HISTORIC AND DESIGN REVIEW COMMISSION

April 20, 2022

HDRC CASE NO: 2022-225
ADDRESS: Various Downtown Locations within the Public Right of Way
LEGAL DESCRIPTION: Public ROW
ZONING: D, H, RIO-3
CITY COUNCIL DIST.: 1
DISTRICT: Alamo Plaza Historic District, Ursuline Historic District, Main/Military Plaza
APPLICANT: Kevin Bowyer/Modus LLC
TYPE OF WORK: Installation of additional communications equipment on downtown street light poles in new locations
APPLICATION RECEIVED: March 31, 2022
60-DAY REVIEW: Not applicable due to City Council Emergency Orders
CASE MANAGER: Edward Hall
REQUEST:

The applicant is requesting a Certificate of Appropriateness to install additional communications equipment (CBRS) on green fluted street light poles in seven (7) locations. The locations are noted below:

ZD-1

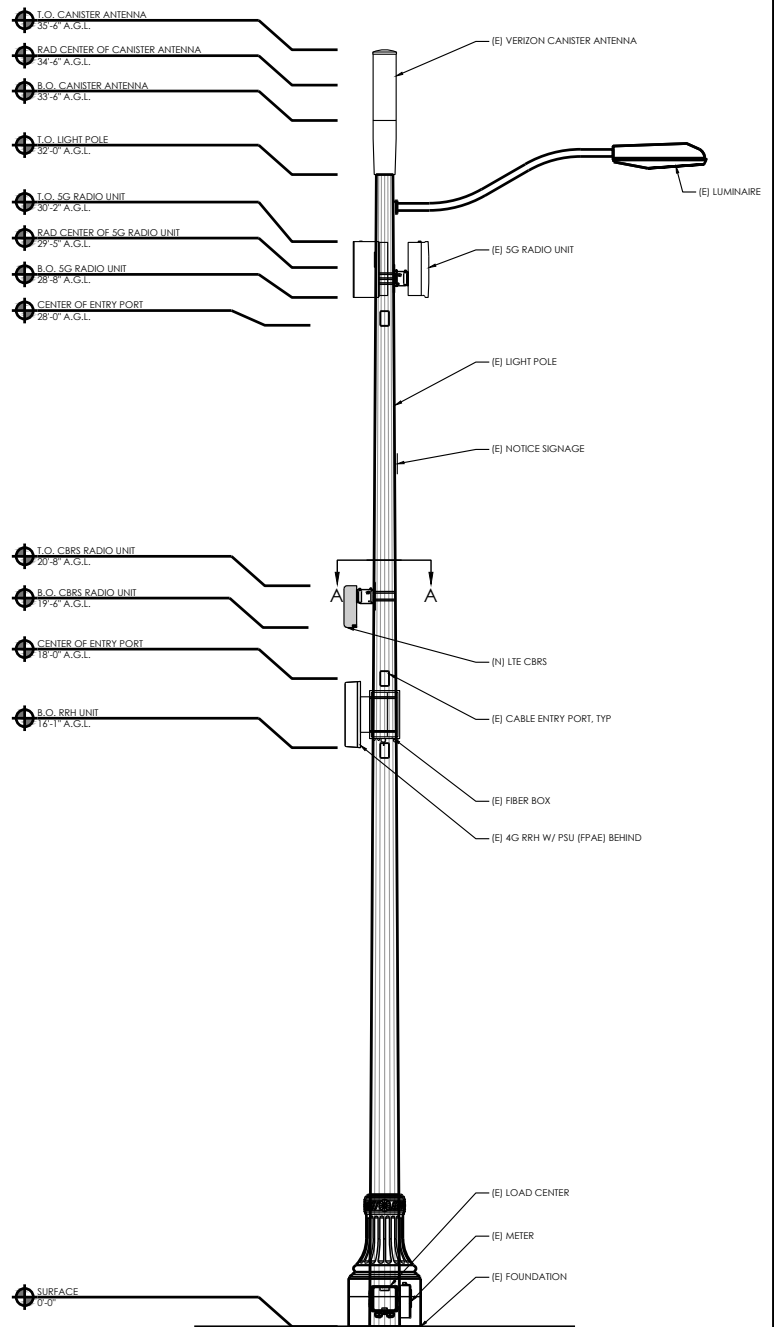
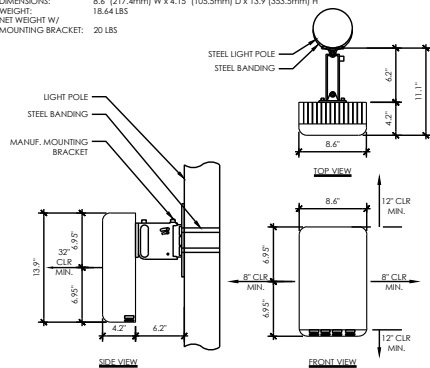
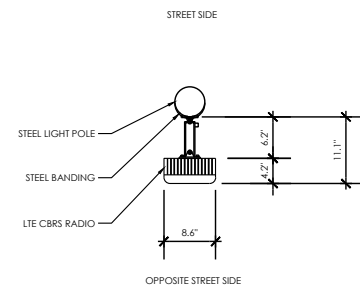
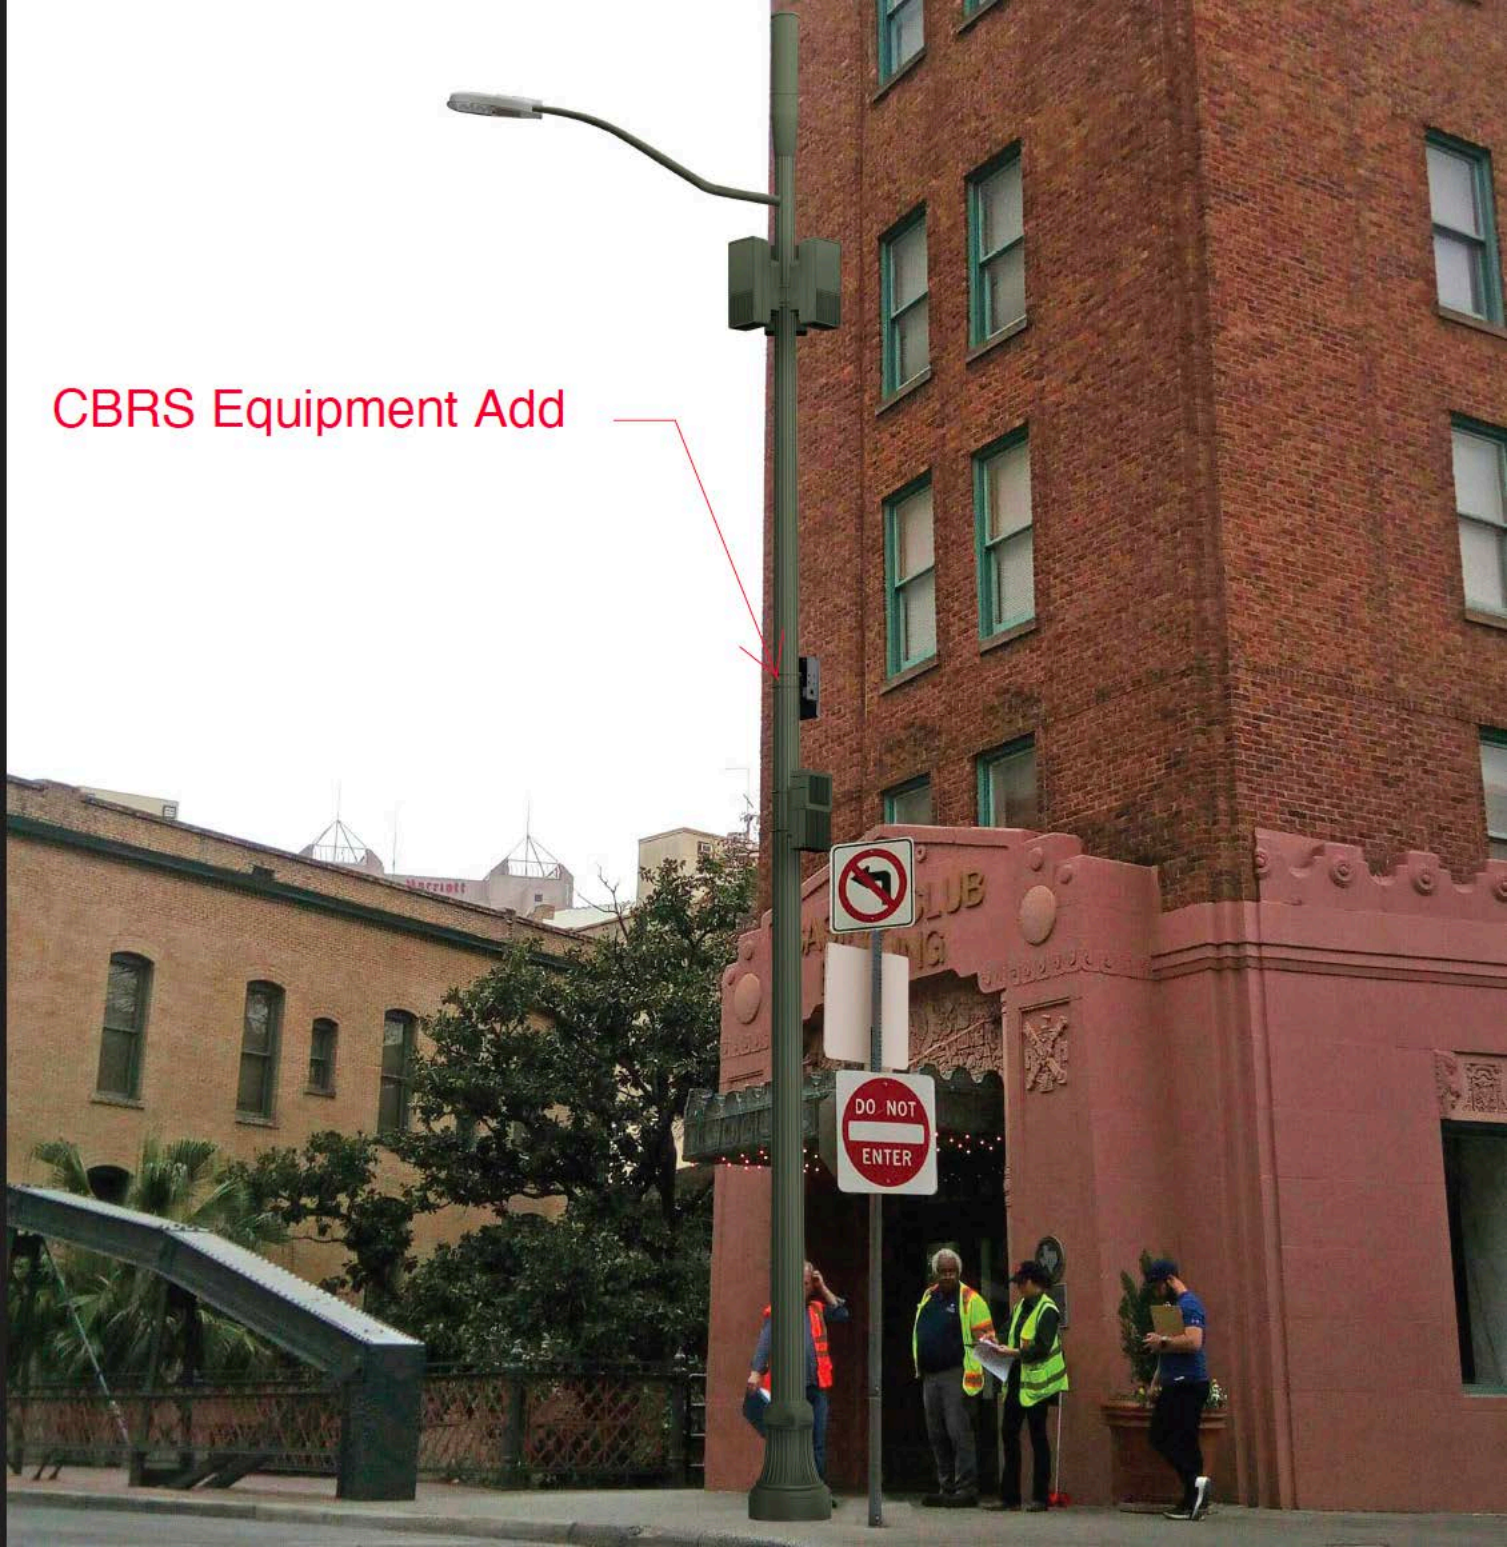
- g. NEW EQUIPMENT – The applicant has proposed to install one additional radio above the middle location of equipment. Generally, staff finds this to be appropriate.

- h. APPEARANCE – All panels, radios, antennas and associated shall match the street light pole in color. Additionally, no wires or other conduit shall be visible.

Staff recommends approval based on findings a through g with the following stipulations:

- i. That all stipulations of the Pilot Program and past approvals apply. These stipulations are outlined in finding d.
- ii. That all panels, radios, antennas and associated shall match the street light pole in color. Additionally, no wires or other conduit shall be visible.
- iii. Archaeology – The project shall comply with all federal, state, and local laws, rules, and regulations regarding archaeology, as applicable.
